THM 4L60-E/4L65-E "UPDATE HANDBOOK"

THM 4L60-E/4L65-E

THM 4L60-E TCC "PWM" SOLENOID ADDED IN 1995 AND NEW OIL PUMP ASSEMBLY FOR 1995

Figure 2

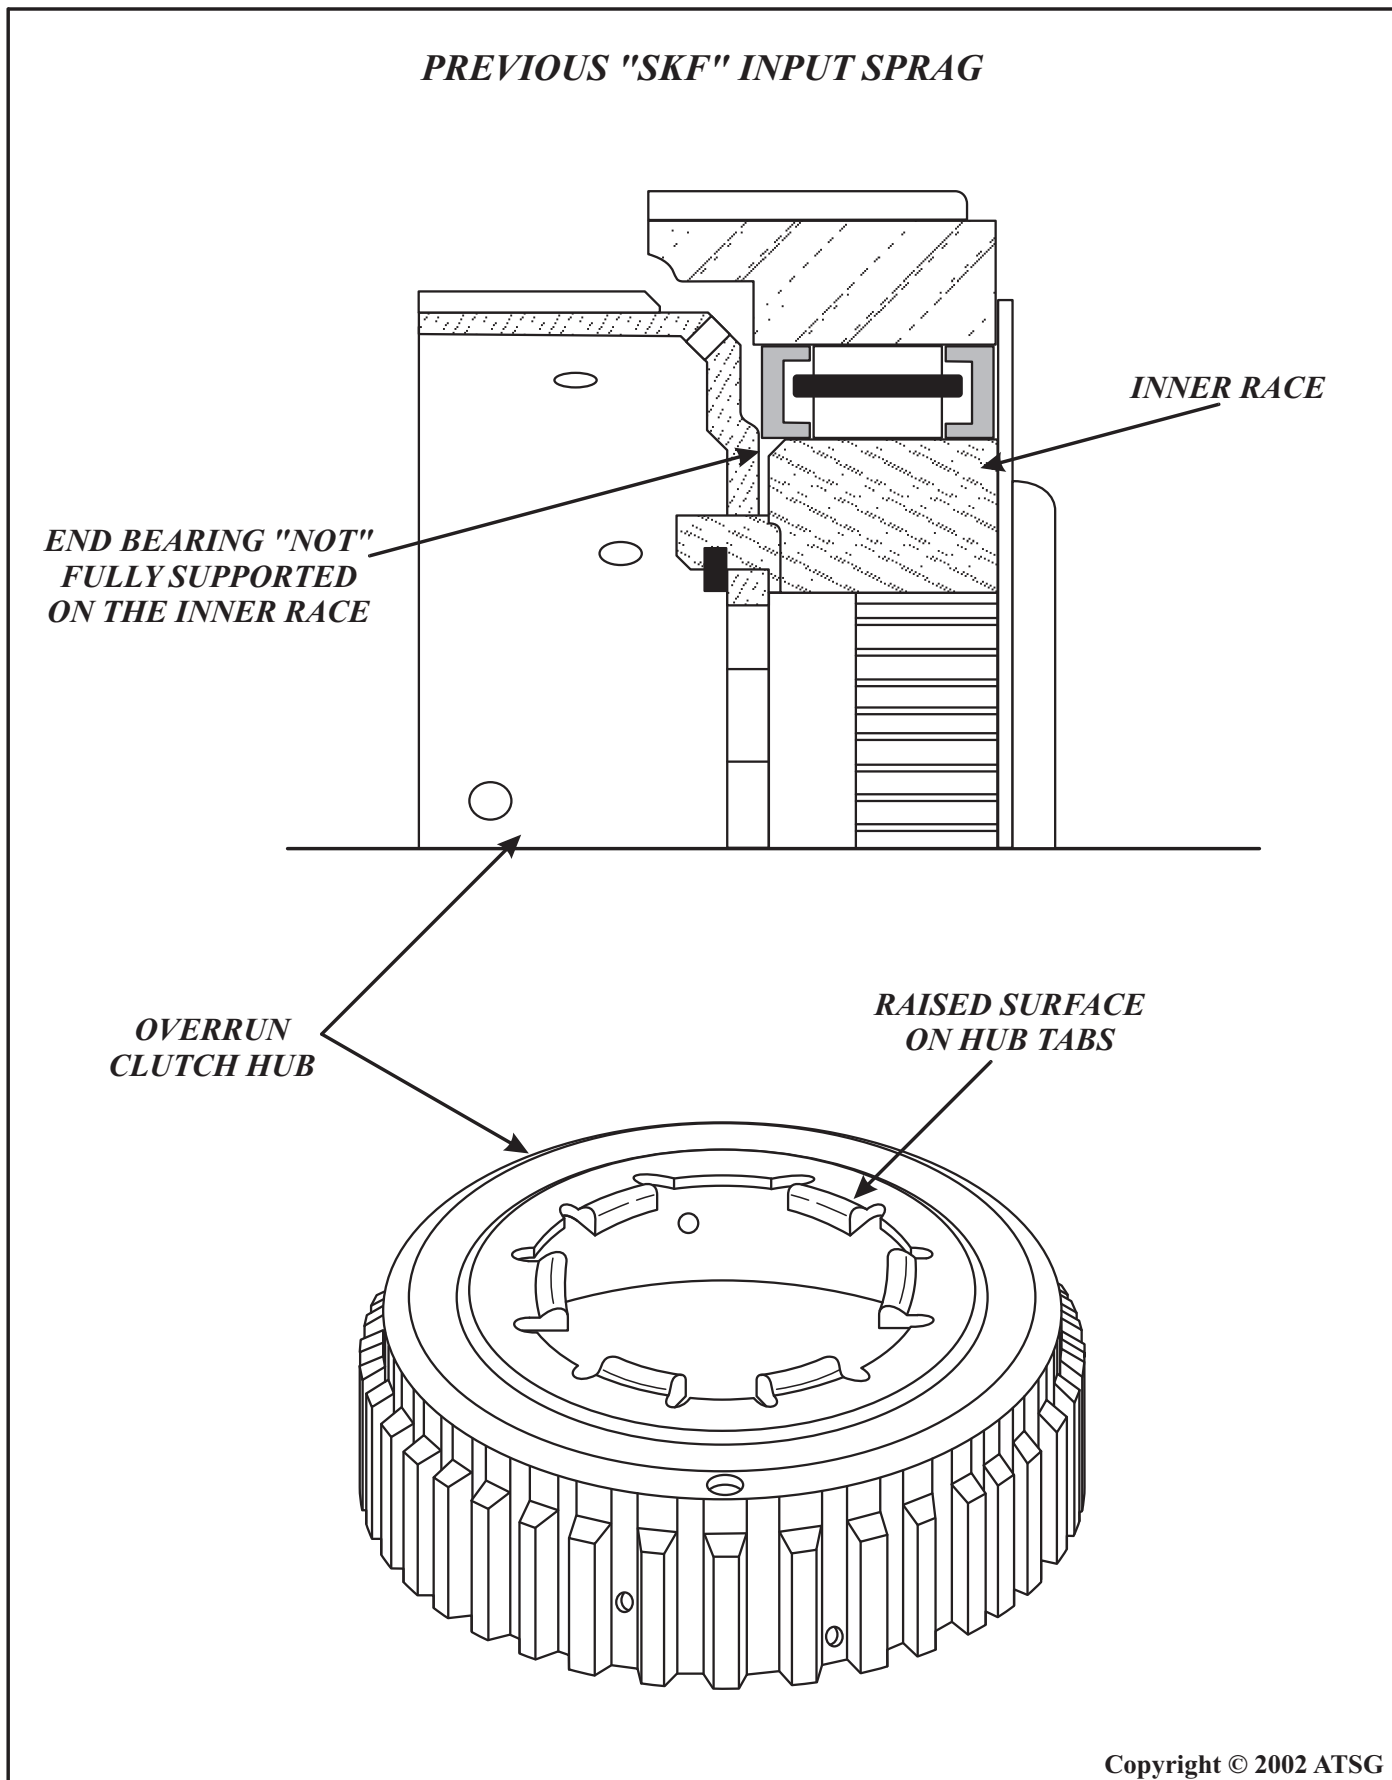
- (1) FORWARD SPRAG INNER RACE - Dimensional changes on the new design inner race, with the removal of the chamfer, and now fully supports the sprag end bearing, on the end bearing inside diameter. Compare the previous cutaway illustration in Figure 2, with the current cutaway illustration in Figure 3.
- (2) OVERRUN CLUTCH HUB - Dimensional changes on the new design clutch hub, with the elimination of the raised tabs on the teeth. The back side of the clutch hub is now flat, to keep the end bearing inside diameter fully on the inner race. Compare the previous clutch hub illustration in Figure 2, with the current clutch hub illustration in Figure 3.

Figure 1

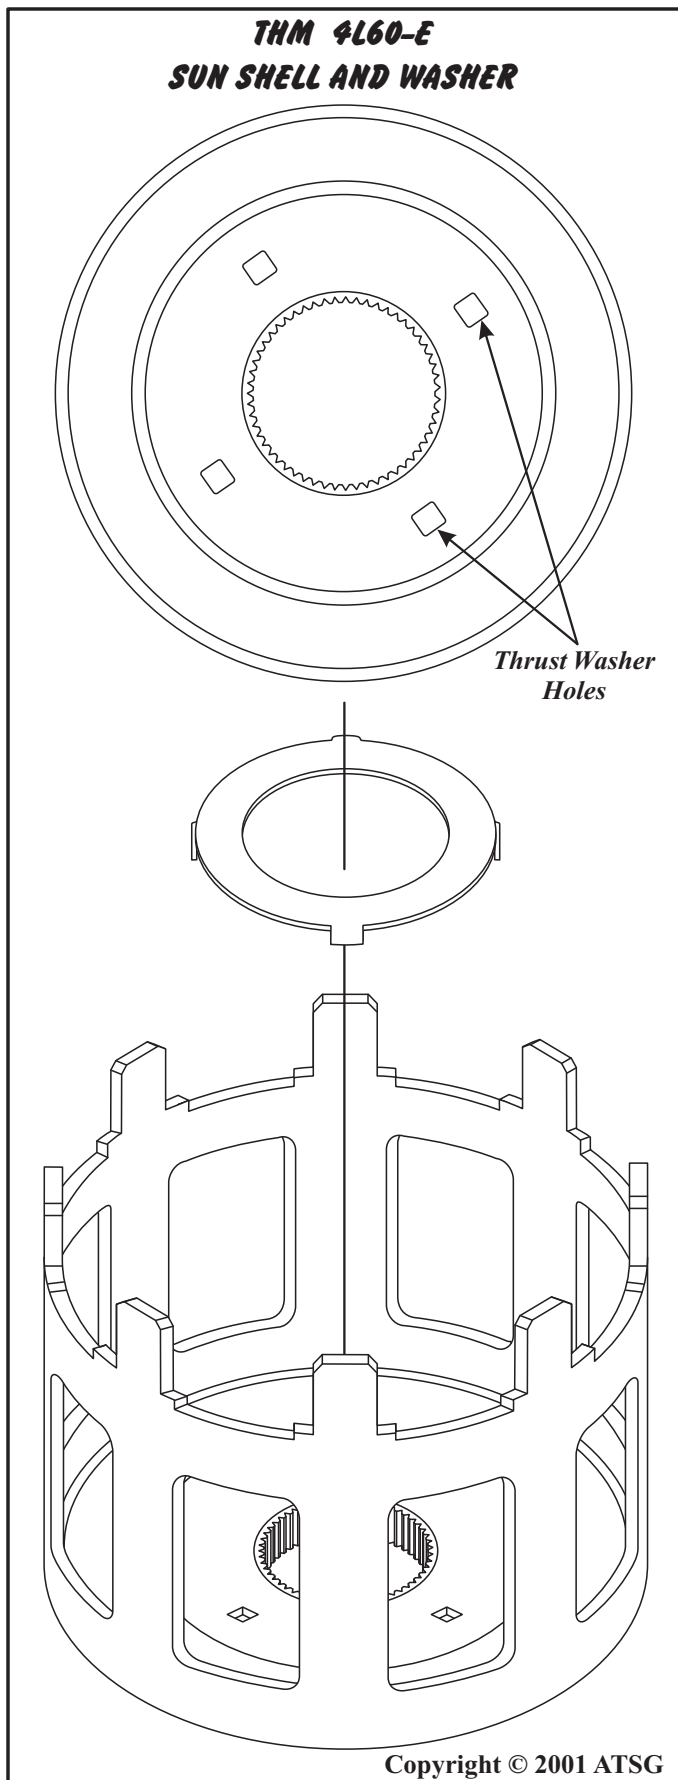
- (1) SUN GEAR SHELL - The holes in the sun shell for the previous thrust washer have been eliminated, as shown in Figures 1 and 2, to accommodate the new thrust bearing.
- (2) REACTION CARRIER SHAFT - Modified on the rear surface to accommodate the added thrust bearing, as shown in Figures 3 and 4.
- (3) THRUST BEARING - Added for increased durability, as shown in Figures 3 and 4.

Figure 1

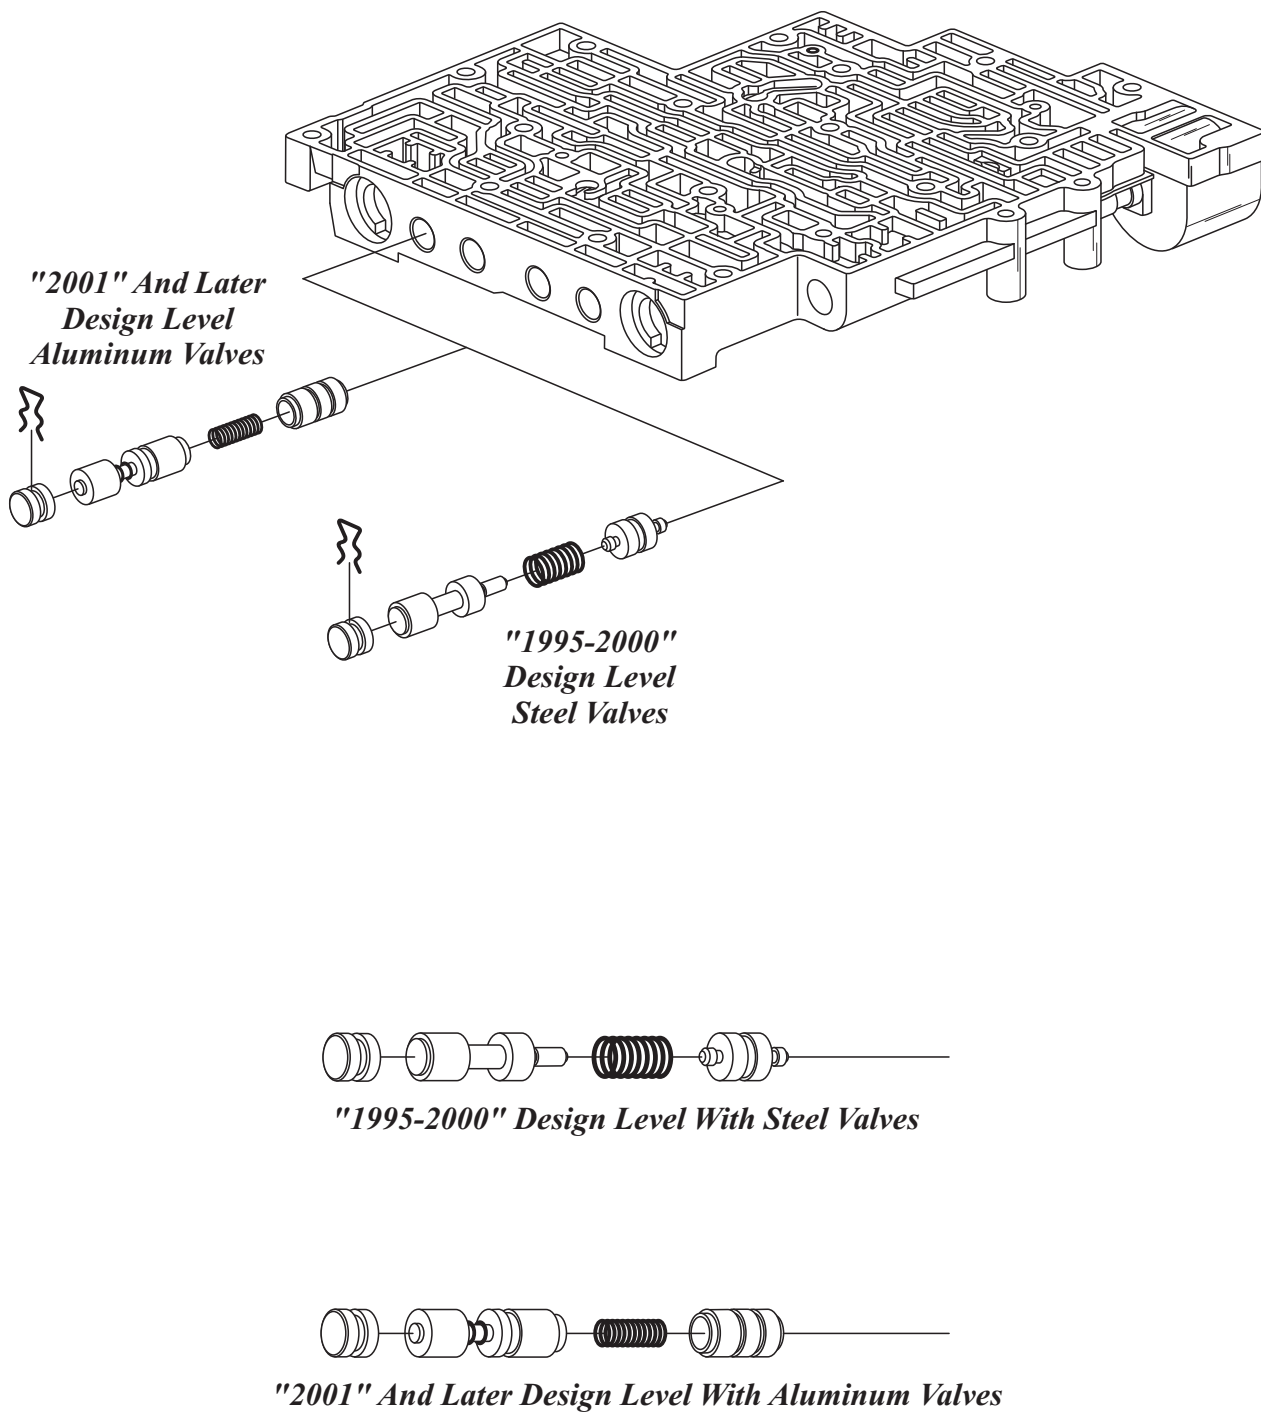
CHANGE: Beginning at the start of production for 2001, all 4L60-E transmissions were produced with a new design converter clutch regulator valve line-up located in the valve body, in the location shown in Figure 1.

- (1) **TCC REGULATOR AND ISOLATOR VALVES** - This line-up now has re-designed aluminum TCC Regulator Valve and Isolator Valves, instead of the previous steel, as shown in Figure 1.
- (2) **VALVE BODY CASTING** - Has changed in the worm track areas that are identified inside the circles, as shown in Figure 2, to accommodate the new design converter clutch regulator and isolator valves.
- (3) **SPACER PLATE** - There are two holes in the spacer plate that have been revised, as shown in Figure 3, to accommodate the new design converter clutch regulator and isolator valves.
